Submission: Draft Aerotropolis Precinct Plan – Northern Gateway

This submission has been prepared by Elton Consulting on behalf of Luddenham Property Group (LPG) in response to the release of the Draft Aerotropolis Precinct Plans for the Western Sydney Aerotropolis Precinct.

**Re: Heritage Advice on the Western Sydney Aerotropolis Draft Precinct Plan - [REDACTED] Elizabeth Drive,
Luddenham**

Figure 5: High points and open space

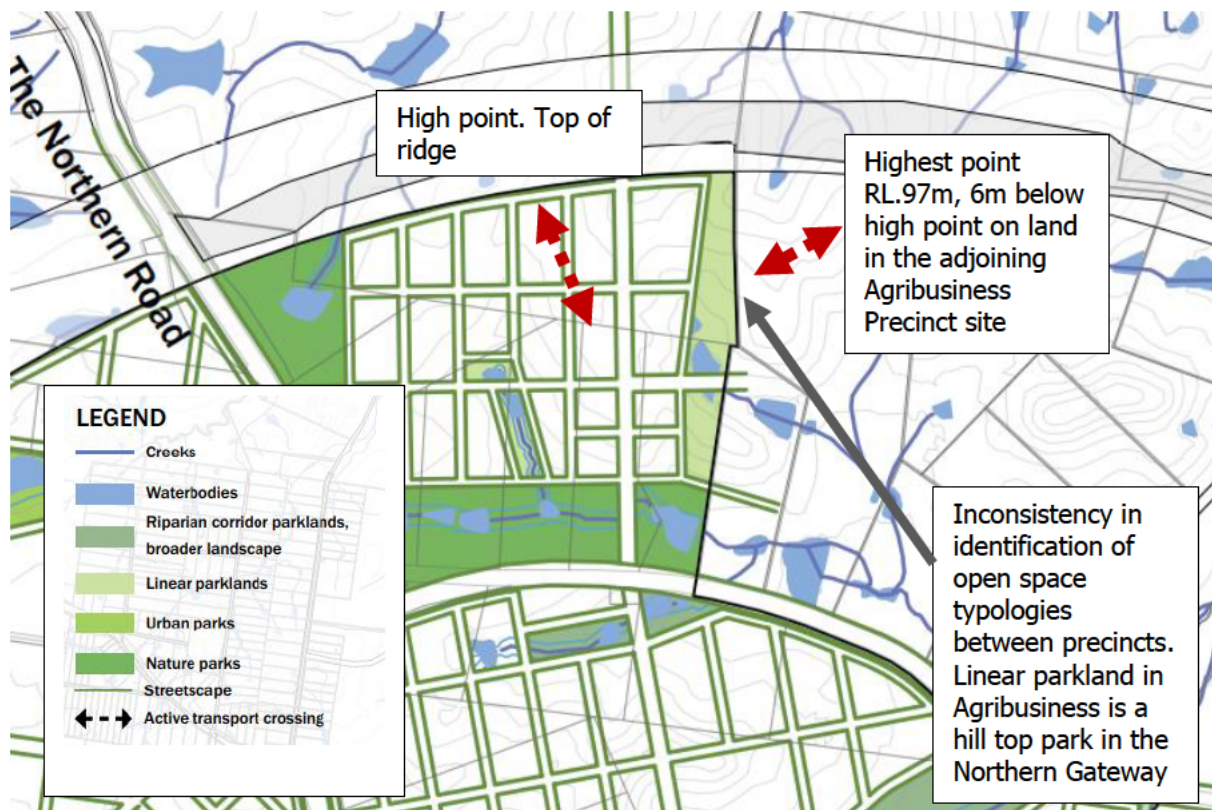
The quantum and function of open space identified in the Draft Precinct Plan is questioned. This is particularly the case on for land north of Elizabeth Drive and south of the M12. This land is zoned Enterprise. It is presumed that development will be largely bulky warehousing, freight and logistics and supporting infrastructure. These uses are not necessarily employment generating in terms of job creation on site. Who will be using this hilltop park? How will they use it?

Using topography as a rational for the allocation of open space, prohibiting all other forms of business or enterprise development is at odds with the Aerotropolis SEPP and an evidenced based approach to the arrangement of land uses within a site. The site does include areas of moderately challenging topography, however, a site-specific assessment can be undertaken to determine the extent to which the land can be developed and includes development feasibility. Assuming the cost of developing the land is relative and should not be a factor in the strategic planning for the Precinct. Further, the *draft Aerotropolis Precinct Plan* includes built form typologies that could be adopted for steeper sites.

Further, the manner in which the *draft Aerotropolis Precinct Plan* proposed to preserve these now is inconsistent. In the case of the LPG Elizabeth Drive site, it is not the highest point. In fact, the higher portions of ridgeline are shown in the adjoining Agribusiness Precinct as being completely developed for enterprise (refer **Figure 5**). If the advice from DPIE were to represent the rationale behind the allocation of a park on the Northern Gateway Precinct, why is the approach to the allocation of land use so different in the adjoining Agribusiness Precinct. This needs to be urgently reviewed with greater attention to detail in precinct planning between these two precincts. This is even more important given the east of the Northern Road and north of Elizabeth Drive in the Agribusiness Precinct is the only area in the Agribusiness Precinct zoned Enterprise rather than Agribusiness of which this parcel represents nearly 40 hectares.

Figure 6: Views Northern Gateway Enterprise zone

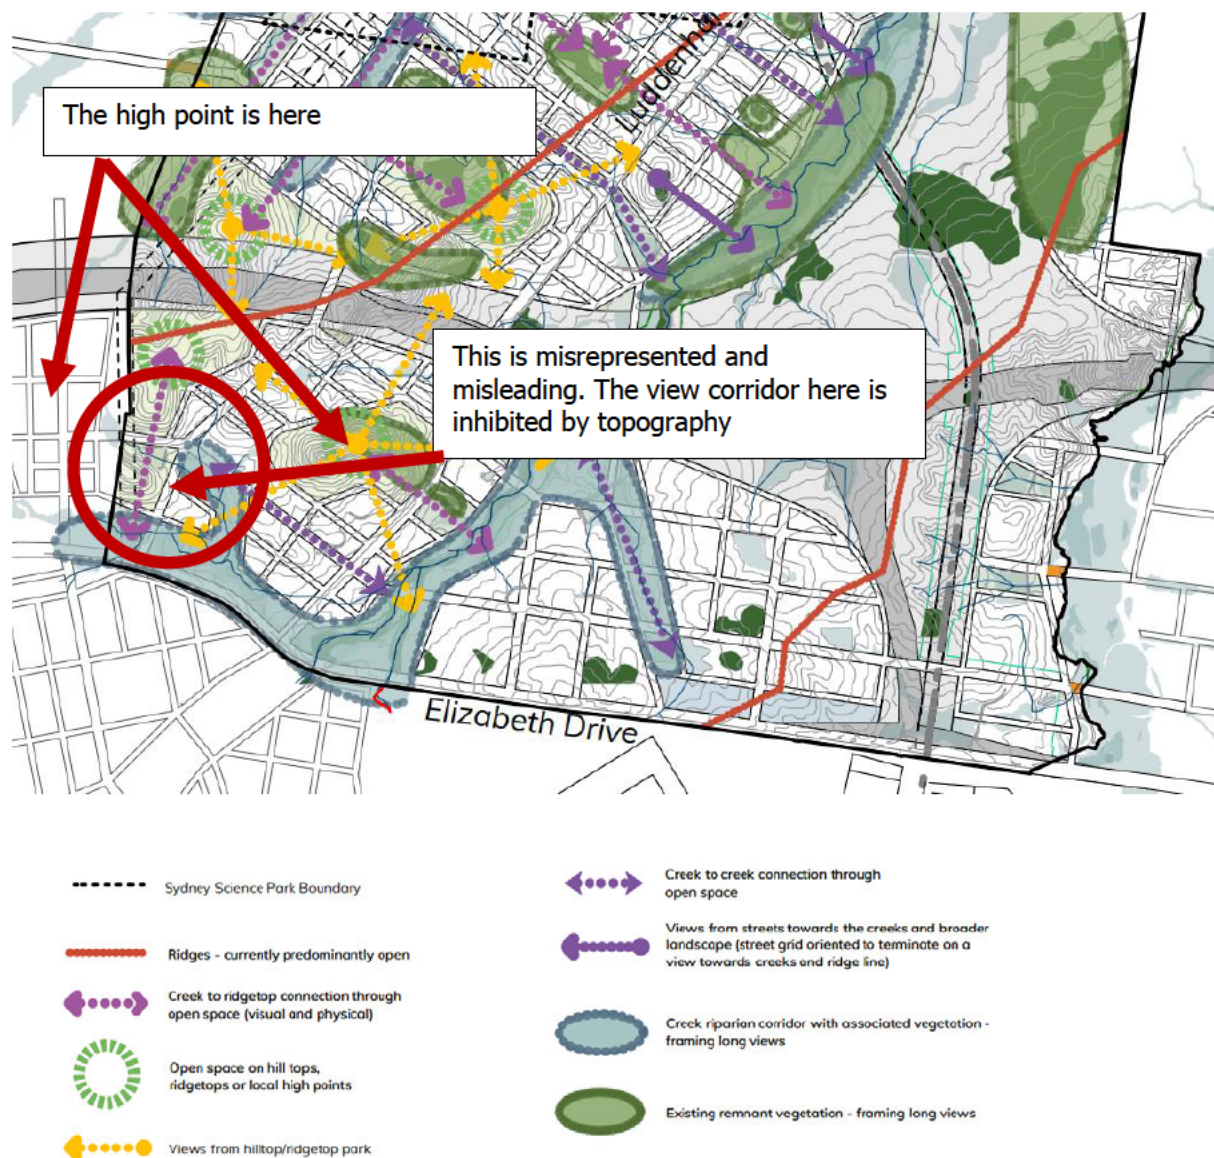
As noted above, the lodation of hill top parks is questioned because it is simply not a high point. The high point is 6m higher on the adjoining land in the Agribusiness Precinct shown in the Precinct Plan as completely developed in a grid.

The equivilant image for the neighbouring precinct represents the principles differently. This suggests that the *Northern Gateway and Agribusiness Urban Design Reports* were completed prior to the visual analysis rather than the key visual corridors informing the design.

Figure 10: Transport strategy (Northern Gateway)

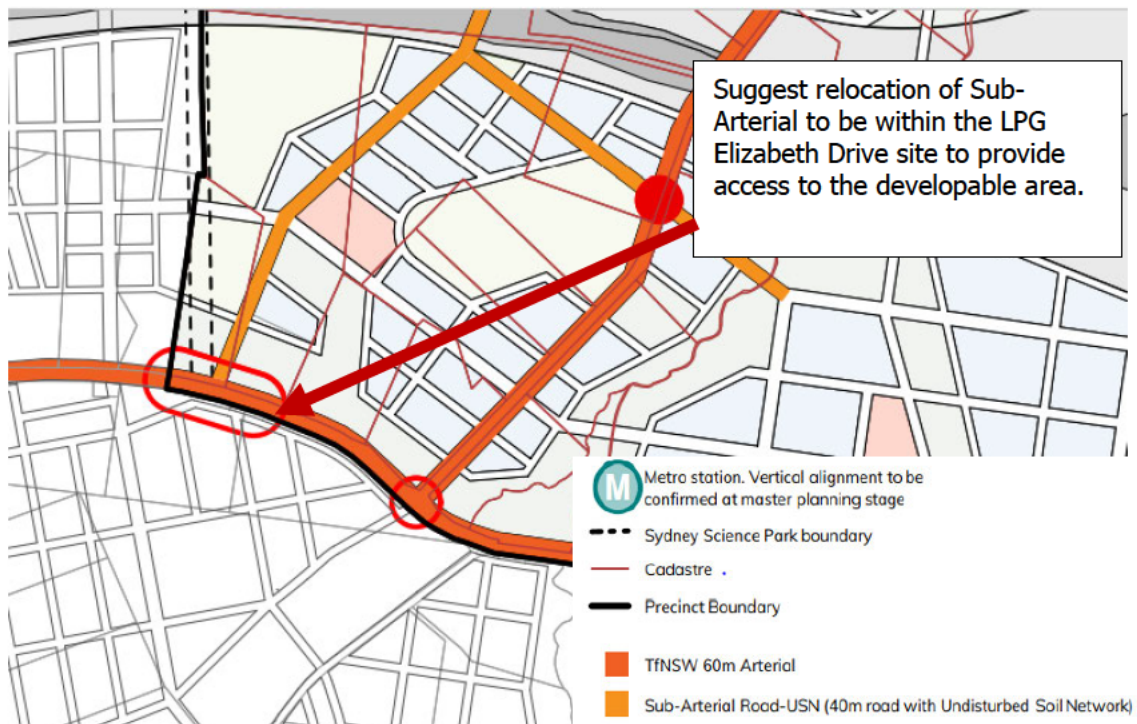
There are two roads shown as sub-arterial connections to Elizabeth Drive in close proximity in the Northern Gateway and Agribusiness Urban Design and Landscape Reports (**Figures 10, 11 & 14**). In the draft Aerotropolis Precinct plan only one is shown in the Aerotropolis Framework on page 144 (and referred to as “Primary Arterial with a confirmed signalised intersection”) and two shown again on the Street Typologies plan on page 146.

Further, the location of the Sub-Arterial/Primary Arterial road to Elizabeth Drive at the western location in the Agribusiness Precinct will involve significant investment in a bridge to overcome the topography. Finally, as noted earlier, there is no opportunity for development in the front portion of any of the individual land holdings on the northern side of Elizabeth Drive. Unlocking the developable area will be unfeasible. The LPG Elizabeth Drive site is the key and has the potential to act as a catalyst for development part of the Northern Gateway Precinct and the only opportunity for any development to occur at all in the otherwise land locked Enterprise zoned land in the adjoining Agribusiness Precinct.

Figure 12: Sub-arterial Road Long Section (Precinct Plan)

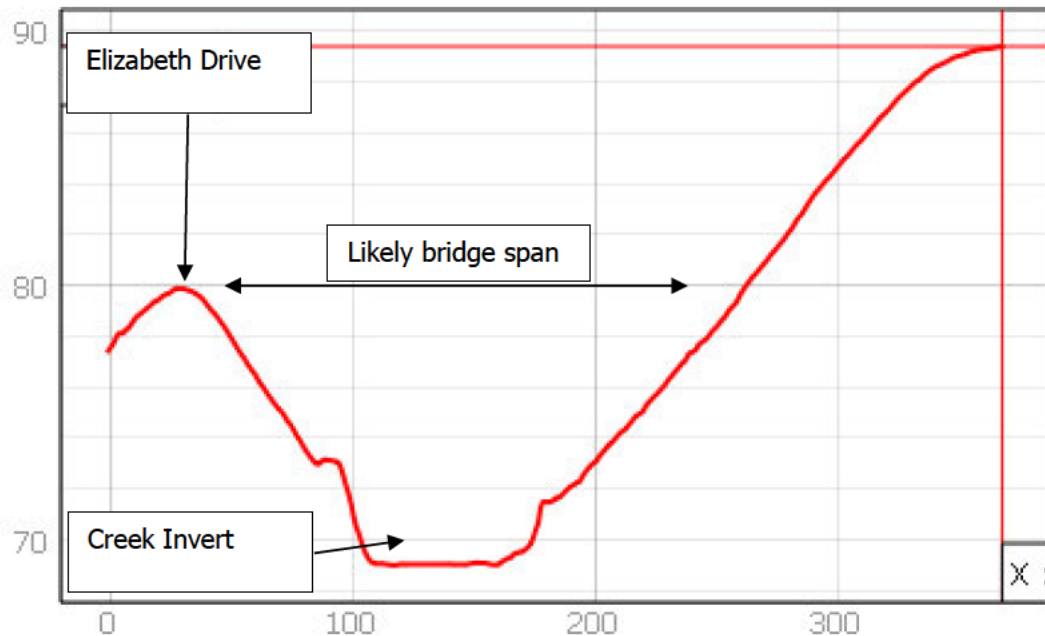
Figure 12 above shows a significant level drop down from Elizabeth Drive to the creek level, some 11m. This would require a bridge structure as filling this much in the riparian zone would likely result in unacceptable environmental consequences. The section also shows that this bridge would need to be in the order of 200m.

Figure 13: Sub-arterial Road Long Section (Proponent Proposal)

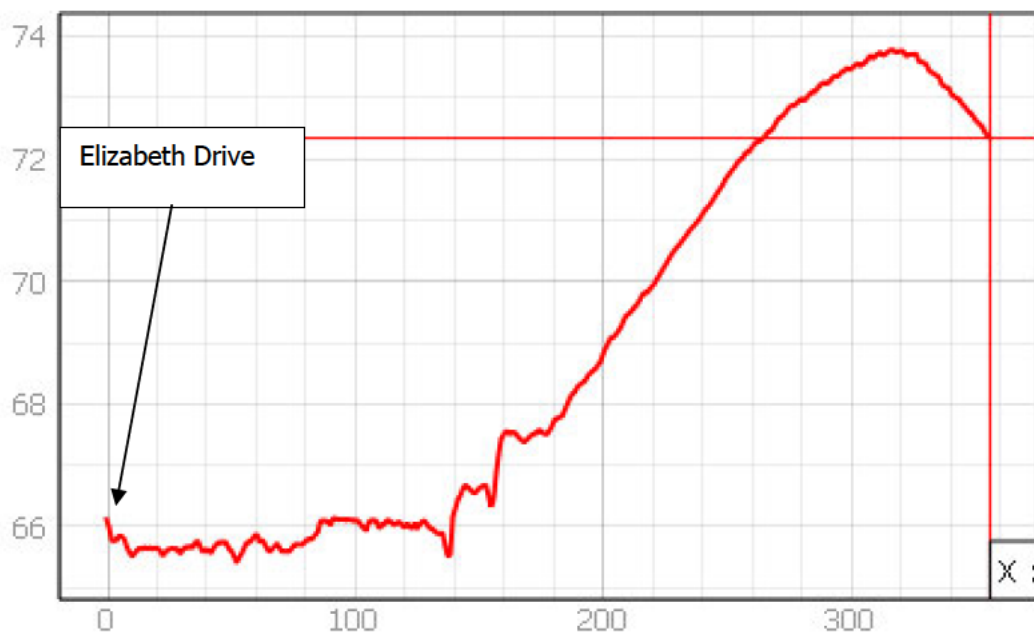
Figure 13 below shows that our Proponent Proposal alignment for the Sub-arterial Road requires no bridge at all, but could manage the creek flows with "at grade" culvert crossing. Using a bridge length of 200m and 20m wide at an average cost of approx \$5,000/sqm our proposed option would save approximately \$20 million and have far less environmental impacts.
